UNITED STATES ENVIRONMENTAL PROTECTION AGENCY  
REGION 10  
1200 Sixth Avenue  
Seattle, WA 98101

**Re: Transformer PCB Investigation Report  
Boeing Plant 2, Seattle/Tukwila, Washington  
EPA ID No. WAD 00925 6819  
RCRA Docket No. 1092-01-22-3008(h)**

The U.S. Environmental Protection Agency Region 10 (EPA) received the Transformer PCB Investigation Data Report (the Report) submitted on December 19, 2003 and prepared by Roy F. Weston on behalf of The Boeing Company (Boeing). The Report has been prepared to fulfill the requirements of the 1994 Administrative Order on Consent (AOC) and the EPA's decision in this matter dated July 5, 2002, which has been incorporated into, and become an enforceable part of the AOC. EPA has determined that, as submitted, the document is not acceptable for review. Therefore the Report must be resubmitted and include all of the requested information below.

Figure 1. Conceptual Site Model for Transformer Investigation Site. (Note: sediment transport is not shown.)

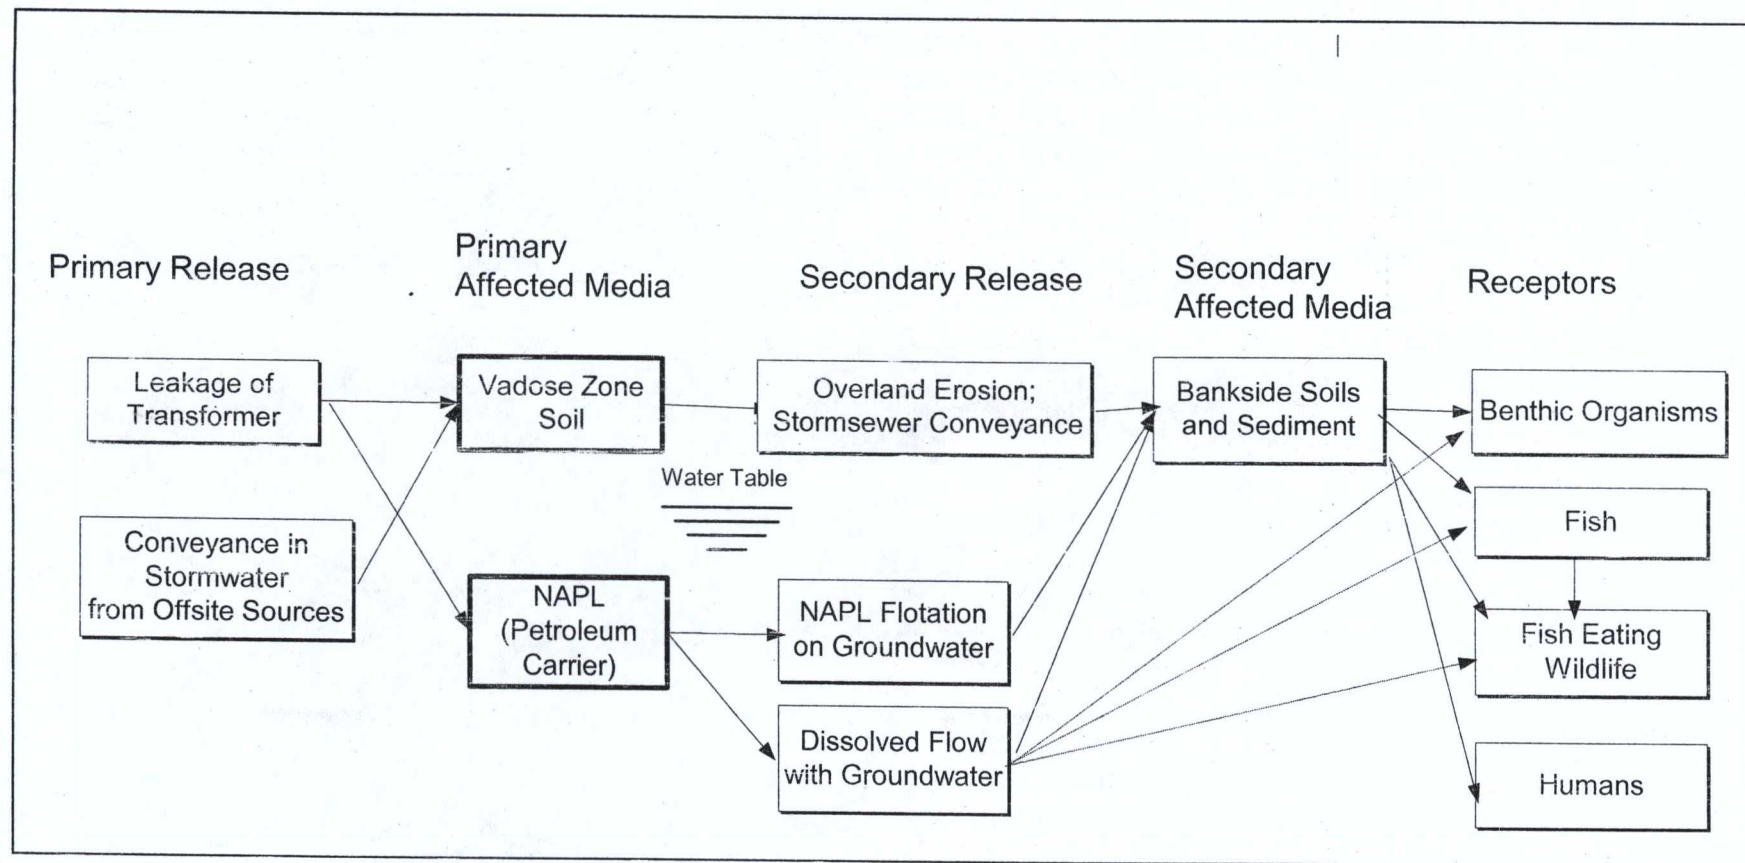
- e) Evaluation of this significant data gap. A crucial gap in the well network occurs between wells PL2-JF01A (or PL2-JF01AR—there is some confusion in the numbering in Figure 1, two wells with the same ID of PL2-JF01A) and PL2-JF02A. As shown in the Work Plan, the direction of groundwater flow is nearly perpendicular to the shoreline and towards the river in this region. Well PL2-006A shows 0.41 ug/L total PCB. The intervening soil boring locations show significant quantities of petrochemicals in borings near the water table. The rebuttable presumption is that dissolved PCBs could potentially be making its way to the river between the first two wells. Also, because of the presence of petroleum hydrocarbons, the potential for

PCBs to move in a non-aqueous "carrier," i.e., as a sheen or as droplets, must be discussed. This may require an additional well that is screened in the high-TPH area and is positioned to show movement (or lack of movement) of PCBs.
